UNITED STATES DEPARTMENT OF COMMERCE United States Patent and Trademark Office Address: COMMISSIONER FOR PATENTS P.O. Box 1450 Alexandria, Virginia 22313-1450 www.uspto.gov

APPLICATION NO.	FILING DATE	FIRST NAMED INVENTOR	ATTORNEY DOCKET NO.	CONFIRMATION NO.
10/799,143	03/11/2004	Lutz Biedermann	B884:56717	7913
	7590 04/03/200 RKER & HALE, LLP	EXAMINER		
PO BOX 7068 PASADENA, CA 91109-7068			HOFFMAN, MARY C	
PASADENA, CA 91109-7008			ART UNIT	PAPER NUMBER
			3733	
			MAIL DATE	DELIVERY MODE
			04/03/2008	PAPER

DETAILED ACTION

German Patent DE 298 10 798

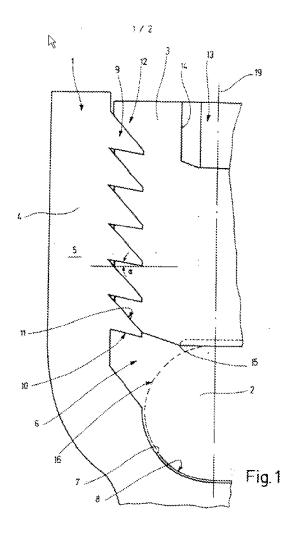
DE 298 10 798 discloses an anchoring element (FIG. 1) comprising a shaft for anchoring in a vertebra or a bone section; a rod (ref. #2) having a pre-determined diameter (D) and an outer surface; a receiving part, which is connected to the shaft and is structured and arranged to connect to the rod, the receiving part (ref. #5) having a longitudinal axis and comprising a U-shaped recess forming a channel for the reception of the rod and two legs (ref.#4) having free ends, the legs comprising a first internal thread, the legs further providing an exterior end surface of the receiving part; and a securing element (ref. #3) comprising a second screw member having a first external thread that engages and cooperates with the first internal thread; whereby a first distance from the exterior end surface of the receiving part to a closest portion of the

outer surface of the rod in an axial direction is a pre-determined distance (A); the first internal thread extending from the exterior end surface of the receiving part to a second distance that is smaller than or equal to the pre-determined distance (A); and the receiving part further comprising an internal undercut (at ref. #6) and the first internal thread extending to the undercut, the undercut having an edge farthest away from the first internal thread, the edge being located at a third distance (B) from the exterior end surface, the distance (B) being larger than the predetermined distance (A). The undercut has a depth that corresponds at least to a depth of the first internal thread. A connection between the shaft and the receiving part is structured and arranged to be a monoaxial connection. The shaft and the receiving part are an integral part.

Applicant has provided a marked up figure of DE 298 10 789, Fig. 1, in the Remarks filed 1/14/2008, showing the right hand thread extending to a position beneath the outer surface of the rod. However, Applicant has not shown where the support for their version of the marked-up figure appears in the DE 298 10 789 specification. Also, Applicant has not provided any explanation or reasoning as to why the DE 298 10 789 right hand threading would extend to a position beneath the outer surface of the rod as shown in the marked-up figure.

Regarding claims 31 and 32, the depth of the undercut of the DE 298 10 789 patent seems to be greater than the depth of a thread.
